BCA Assessment Report

REF Submission - Design Development Phase
Batemans Bay Community Health
7 Pacific Street, Batemans Bay NSW 2536

Revision 3
15 July 2024
Reference: 240062

Figure No. 2 – Rooms identified as 'Treatment Rooms' do not contain a use that triggers a Class 9a use

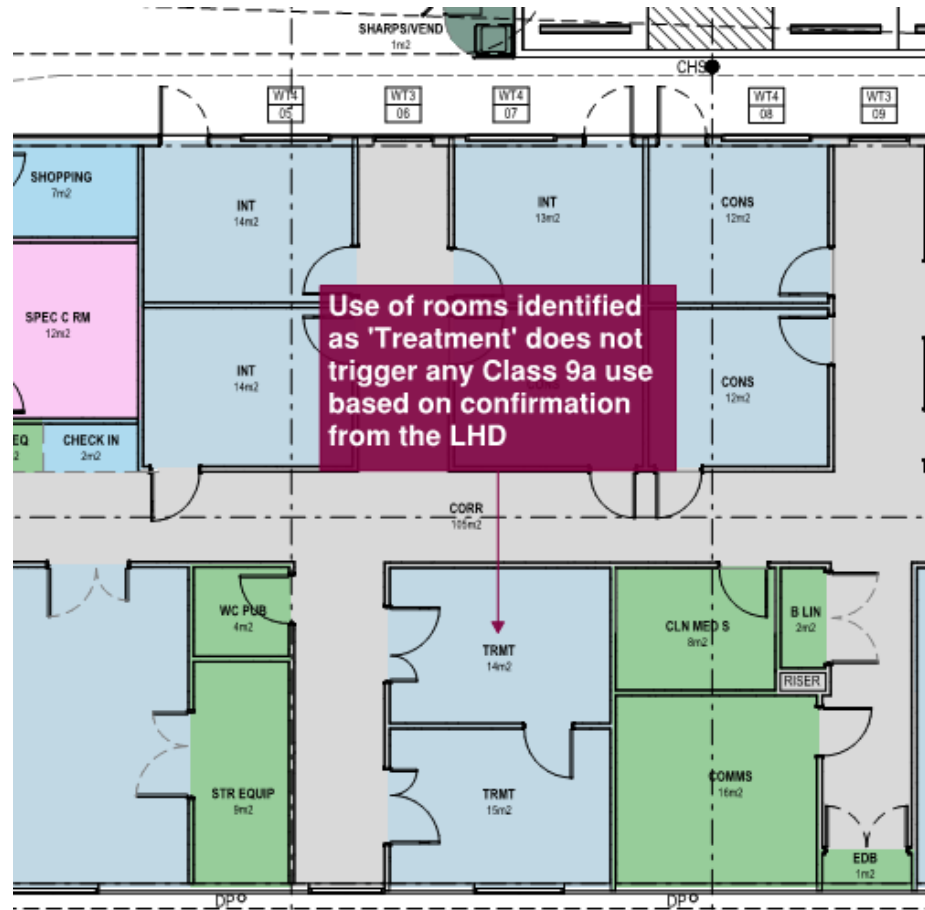
It is noted that the Community Health Building contains two (2) rooms that are identified as treatment rooms.

As a result of the written confirmation from the LHD, the use of the rooms does not trigger any Class 9a use and thus the classification of Class 5 applies to the entire building.

Figure No. 3 – Exposure of external walls of the Community Health Building to the Temporary Demountable Building

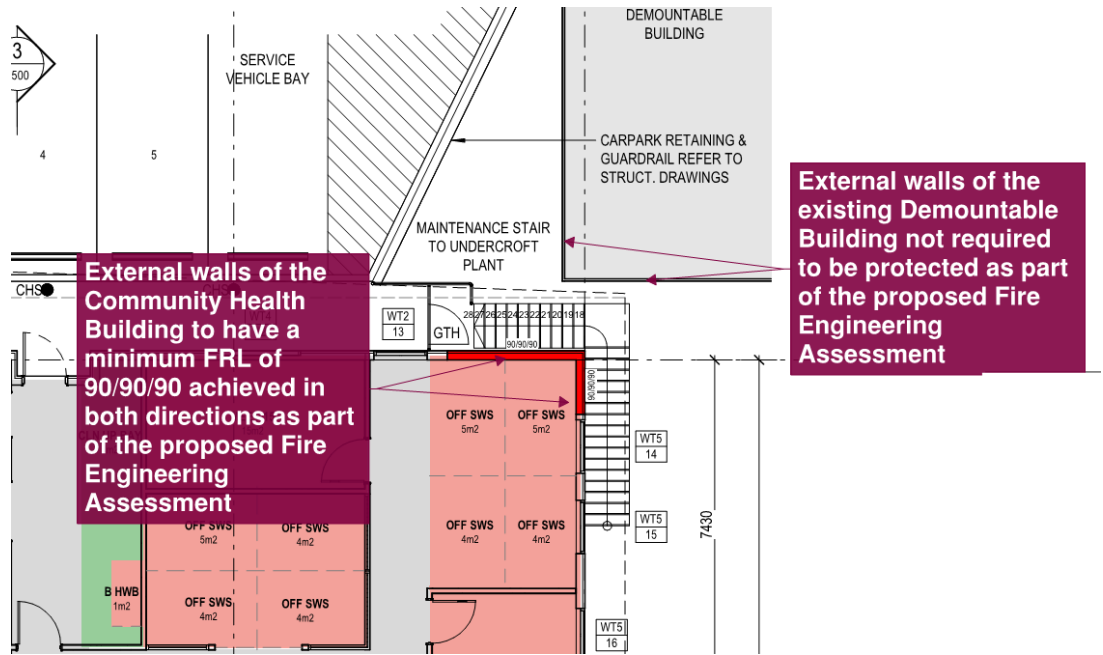
The external walls of part of the Northern Elevation and Eastern Elevation that are situated less than 3 m from the Temporary Demountable Building on site will be required to be provided with an FRL in order to comply with Specification 5. This would require the parts of the external wall to have an FRL of 90/90/90 (if less than 1.5m) and 60/60/60 (if less than 3.0 m).

Due to the fact that the proposed development is causing a non-compliance with the respect to the existing Demountable Building on site, the external wall of the Demountable Building and any associated openings that are situated less than 3 m from the Community Health Building would also be required to be provided with an FRL.

Due to the impracticality of providing an FRL to the existing wall of the Demountable Building, the proposed design solution is for the external wall of the Community Health Building to be protected in both directions.

It is noted that the proposed Fire Engineering Assessment by Arup requires the external walls of the Community Health Building that are situated within 3m of the existing Demountable Building to be provided with an FRL of 90/90/90 which is achieved in both directions. Based on the external wall of the Community Health Building being protected in both directions as part of the Fire Engineering Assessment, there is no requirement for the external wall of the existing Demountable Building to be protected.

Figure No. 22: Doorways where circulation space is required to be reviewed in detail to ensure that compliance is achieved

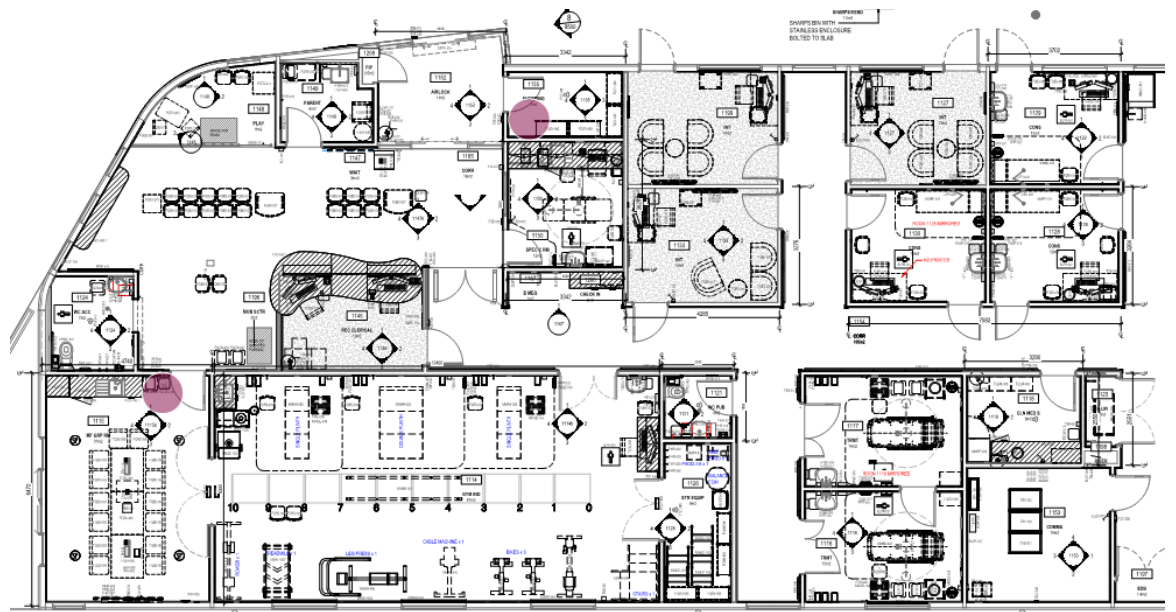
From a review of the Design Development Drawings, circulation space is currently deficient or requires close attention to the following doorways to ensure that compliance is achieved in accordance with AS 1428.1 – 2009.

Figure No. 43: Proposed accessible car parking spaces for a person with a disability in proximity to the main entrance of the building

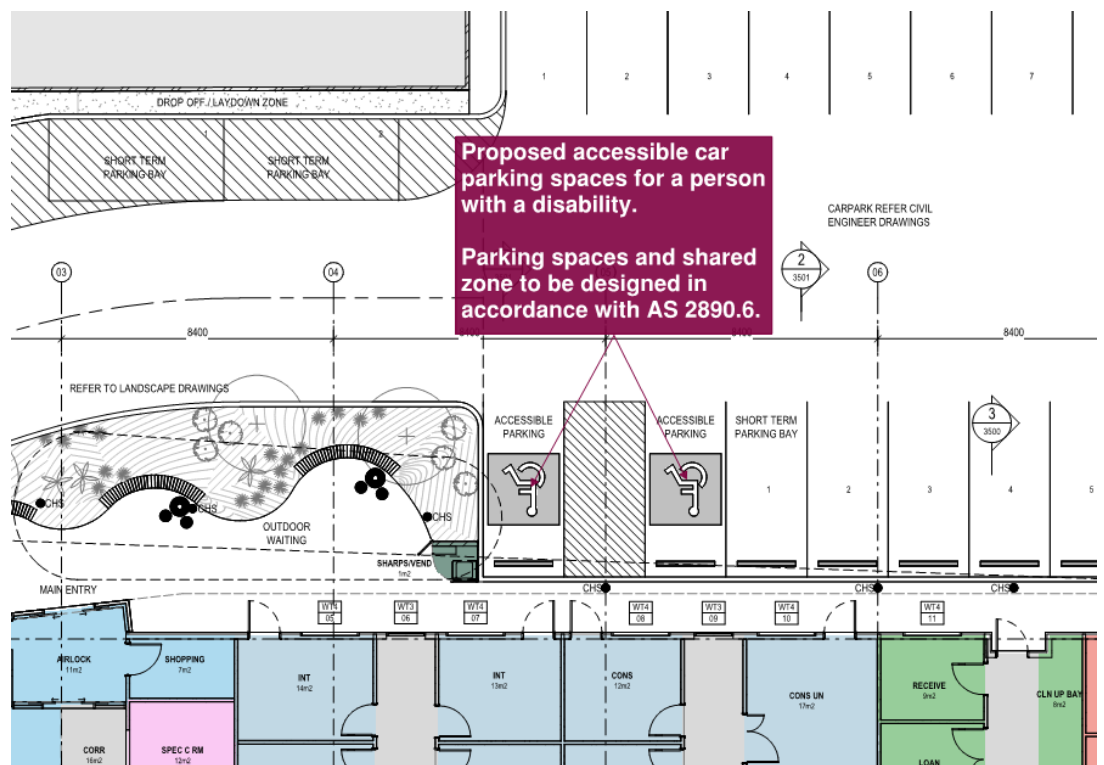
The Design Development proposes two (2) accessible car parking spaces which ensure compliance with Clause D4D6.

The accessible car parking spaces will be required to be designed and constructed in accordance with AS 2890.6.

Figure No. 46: Location of proposed external fire hydrants serving the Community Health Building

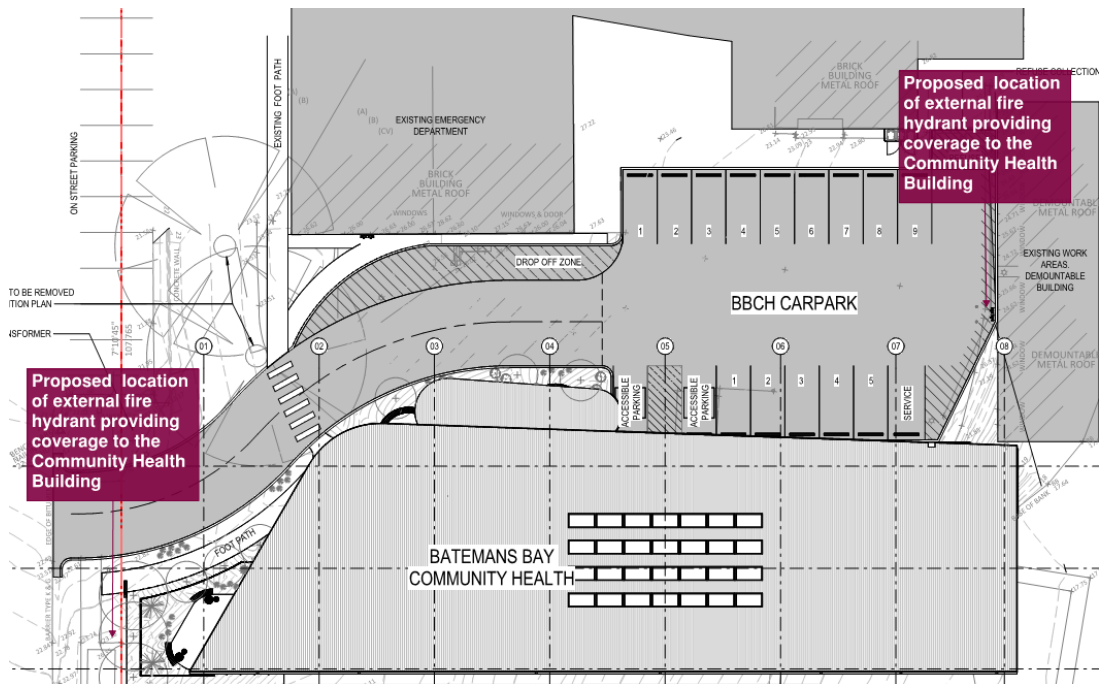
The proposed locations of the external fire hydrants are more than 10 m from the external walls of the proposed building they are providing coverage to. The fire hydrant within the car park which is within 10 m of the external wall of the demountable building is not a non-compliance as the fire hydrant is not providing coverage to demountable building.

Figure No. 47: Unimpeded access required to external fire hydrants

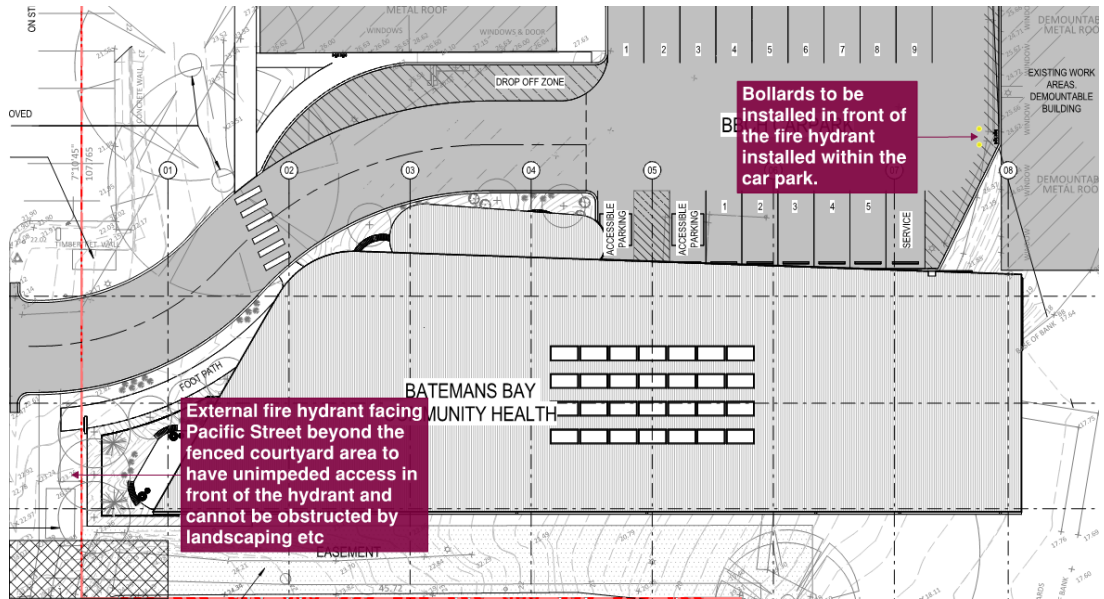
The external fire hydrant installed within the car park will be required to have bollards installed in front so that the booster cannot be obstructed by a parked motor vehicle. The external fire hydrant

installed facing Pacific Street is required to have unimpeded access in front of they hydrant and cannot be obstructed by landscaping etc.

Figure No. 48: Location of existing fire hydrant booster serving the Batemans Bay Hospital site relative to the Main Entry of the proposed Community Health Building

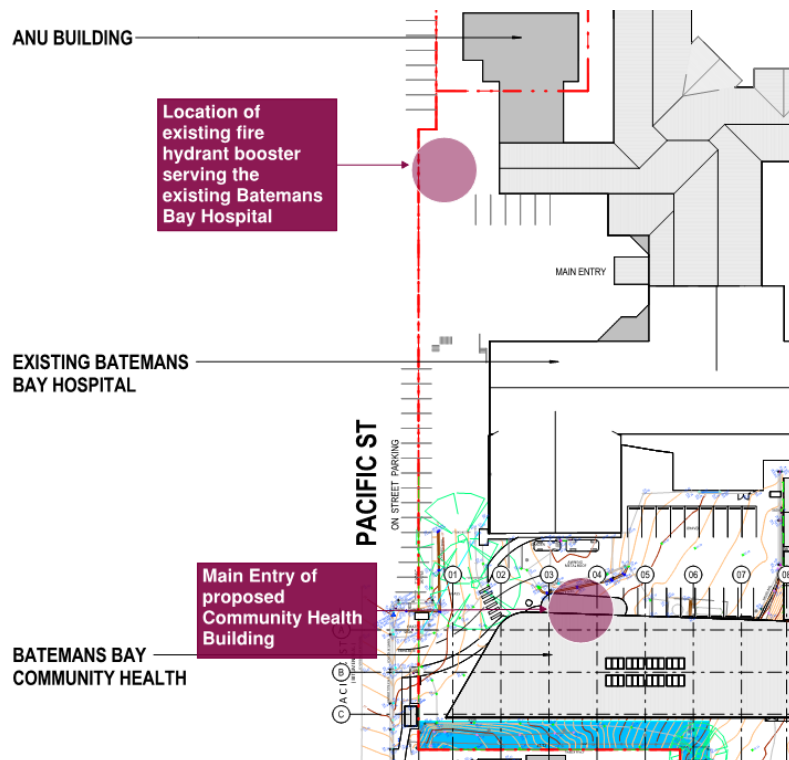
Having regard to the location of the existing booster relative to the main entrance of the proposed Community Health Building, compliance cannot be achieved with Clause 7.3 of AS 24198.1 – 2021 which requires the booster to be located within sight of the principal pedestrian entrance of the building.

Figure No. 49: Location of Main FDCIE within the existing hospital and sub FDCIE within the Community Health Building

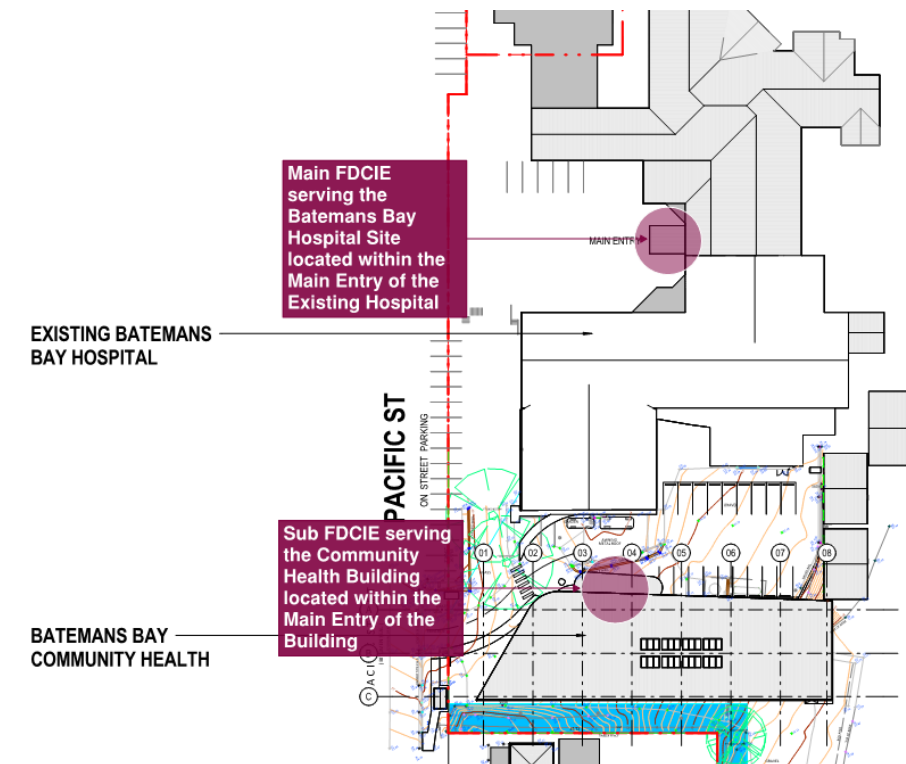
Fire Detection Control Indicating Equipment (FDCIE) will be installed within the Main Entry of the Community Health Building. The new FDCIE will be connected to the main FDCIE (located at the main hospital) and will act as a sub-panel. The main panel is readily accessible and new block plans will be provided to indicate the Community Health Building and new sub-panel.

It is noted that the Fire Services Designer (GHD) has provided written verification that the Automatic Fire Detection & Alarm System is not required to be extended to the building undercroft due to its open nature and the spurious alarm nature of the undercroft area.

Figure No. 50: Minimum fall of 1:80 required within the accessible bathroom containing the toilet pan and shower

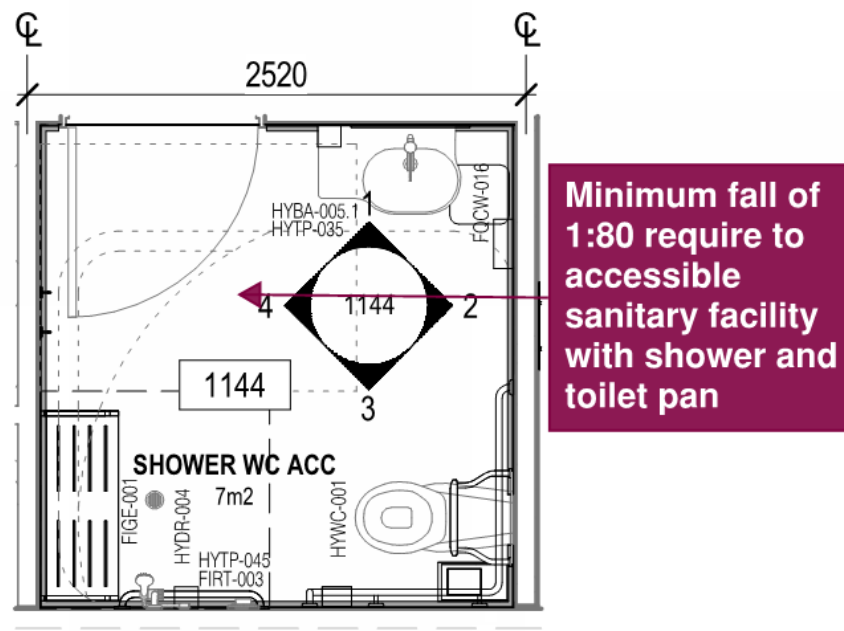
- + The minimum continuous fall of a floor plane to the waste must be 1:80; and
- + The maximum continuous fall of a floor plane to the waste must be 1:50
- + Where an accessible sanitary facility contains a toilet pan and shower, the minimum continuous fall of a floor plane to the waste throughout the room must be 1:80.

Figure No. 52: Public sanitary facilities

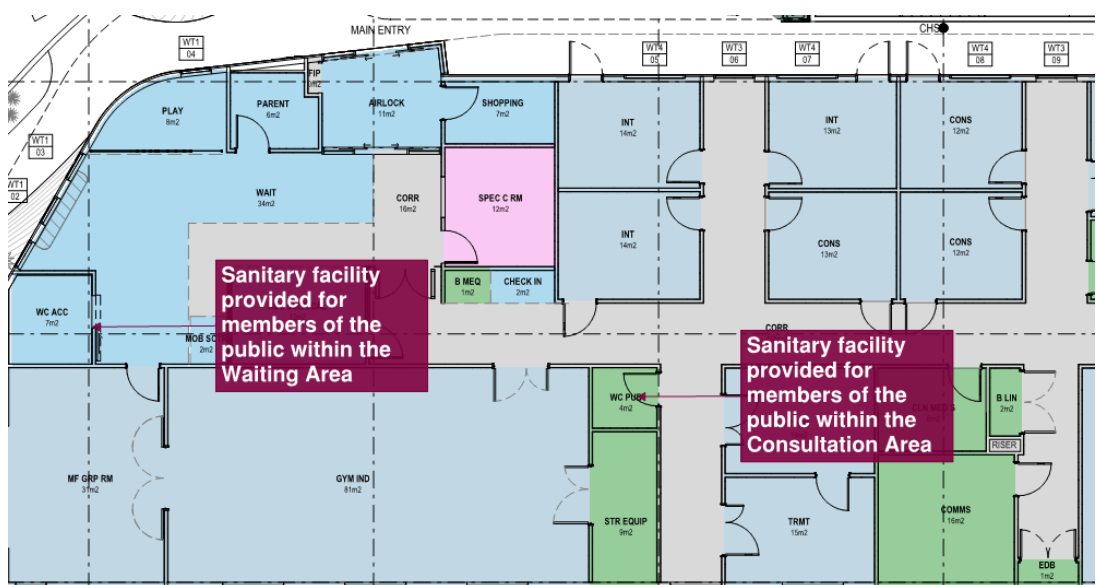
Notwithstanding the requirements of the BCA, it is noted that a unisex accessible sanitary facility for use by a person with a disability has been provided within the Waiting Room in addition to a sanitary facility for a member of the public within the consultation area as detailed in the figure below:
